LAYTON TREE CONSULTING, LLC

Trees & Construction Memo

Re: 5320 Butterworth RD - Tree #33 and #35 Retention Issues - Updated

5330 Butterworth Road
Mercer Island, WA

TREE # 33 PROTECTION PLAN

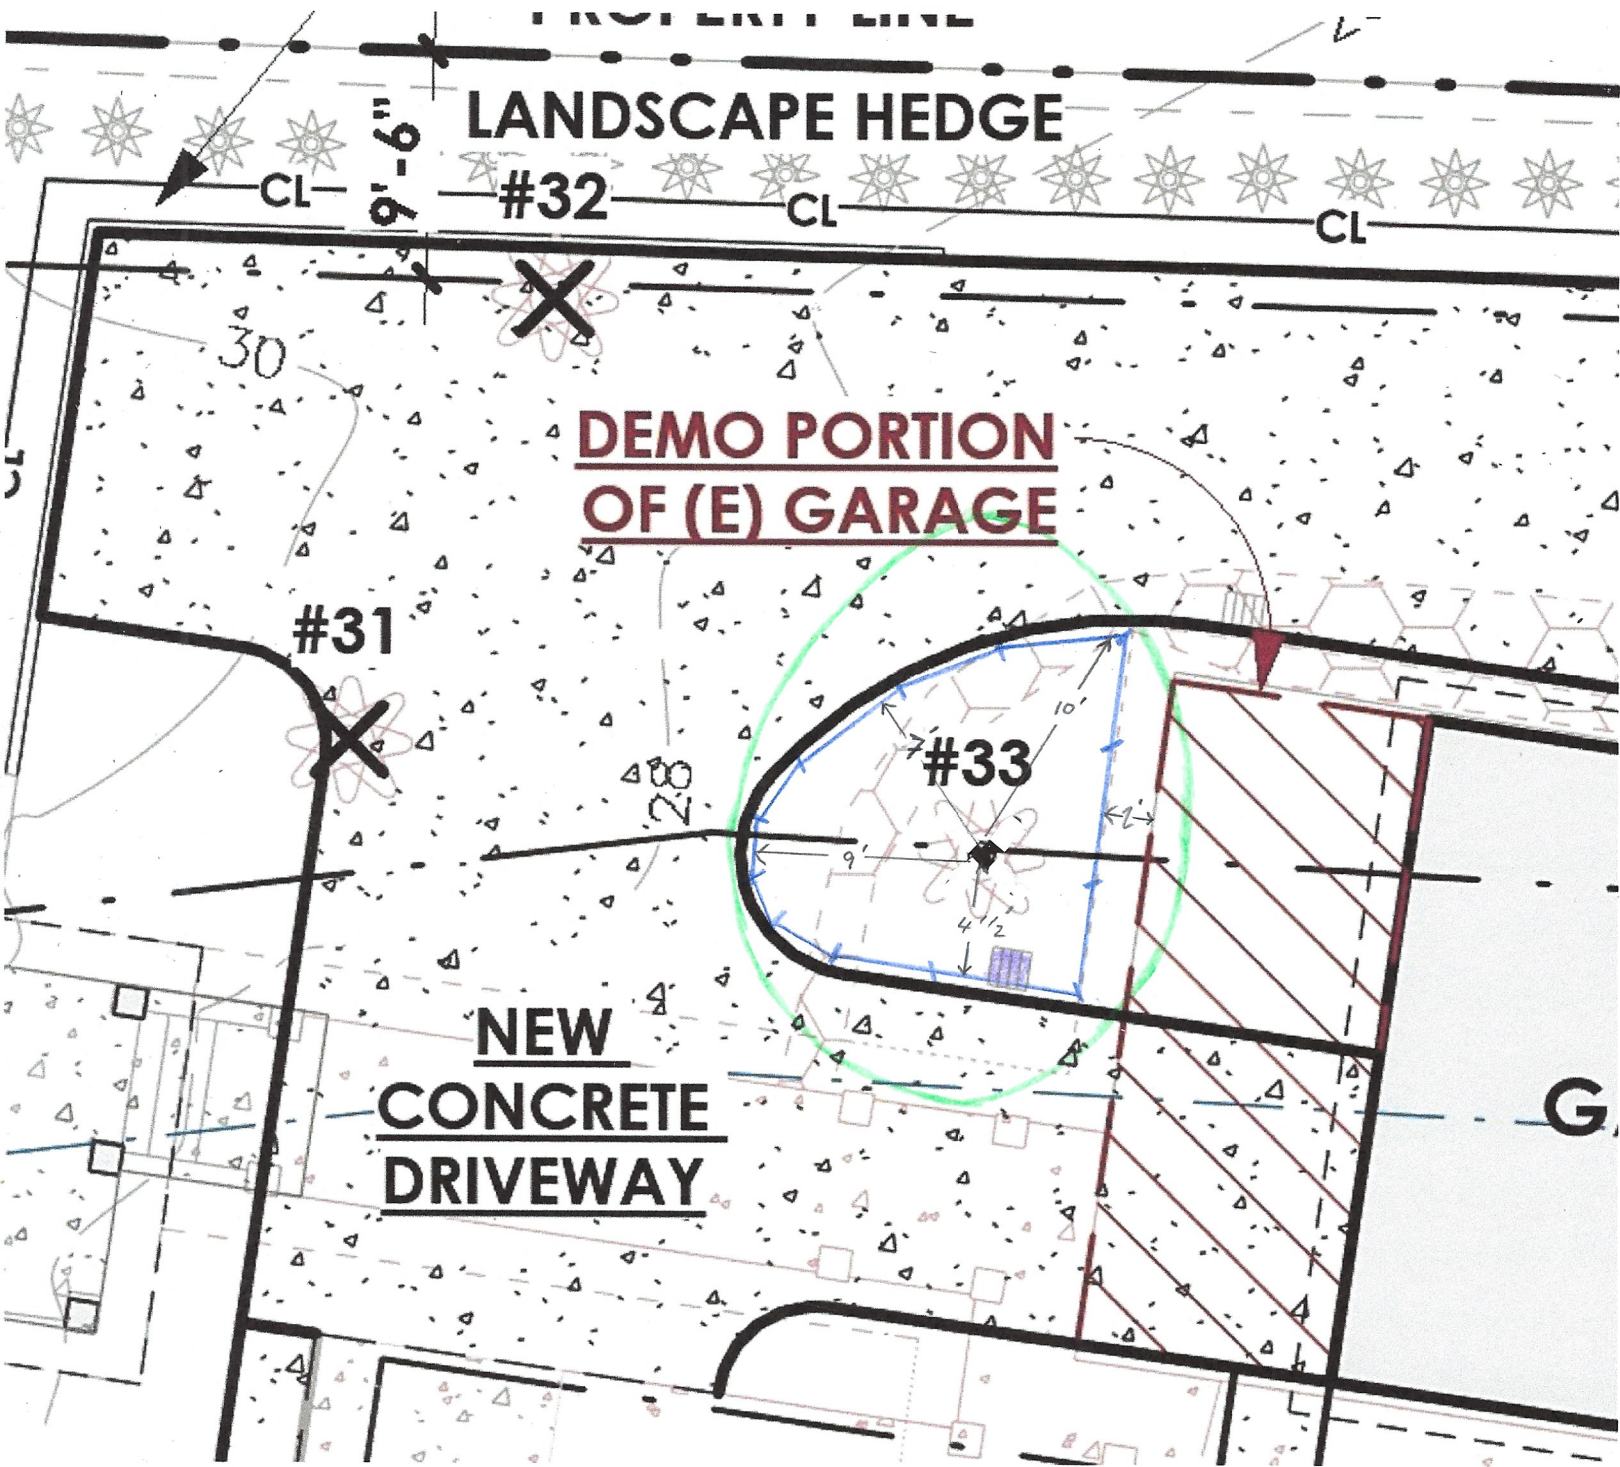
Tree #33 (the 'Exceptional' 12-inch Japanese maple) does not meet the criteria outlined under MICC 19.10.060(A)(3) a, b or c and will need to be retained. The proposed driveway has been redesigned or slightly modified to afford this tree more space for successful retention. See the attached exhibit. Although the tree will be impacted by the new driveway, the proposed impact or anticipated root loss would not be expected to threaten long-term health per MICC 19.10.080 - Tree protection standards B. This is a small, young specimen in good condition. It is only 22-feet in height. See picture below.

The tree protection fencing shall be positioned at the edge of the proposed new driveway and 2-feet off of the existing garage wall to allow for demolition, per the attached exhibit. There will not be any roots beneath the existing garage concrete foundation. The existing stone steps or pavers shall be removed by hand-labor only from within the tree protection area. Once removed, cover the ground within the entire protection area with a +/- 4-inch layer of wood/bark chip mulch.

To prepare the subbase for the new driveway, excavate as little material or topsoil as possible. Any roots that are damaged during work beyond the protection area shall be properly pruned at the new driveway edge. The damaged root shall be pruned clean at sound tissue. Sound tissue is where the root is undamaged and the bark is completely intact. This will help roots to seal off potential decay and allow them to sprout new growth. Consider installing a root barrier at the new driveway edge to deflect root growth downward and prevent future damage. Disturbed

Simply finish the landscape within the tree protection area by applying a fresh 2-inch layer of organic mulch/bark. Keep large plantings, irrigation trenching and the installation of hardscapes outside of the tree protection area. All finish landscape work within the tree protection area shall be done utilizing hand-labor only.
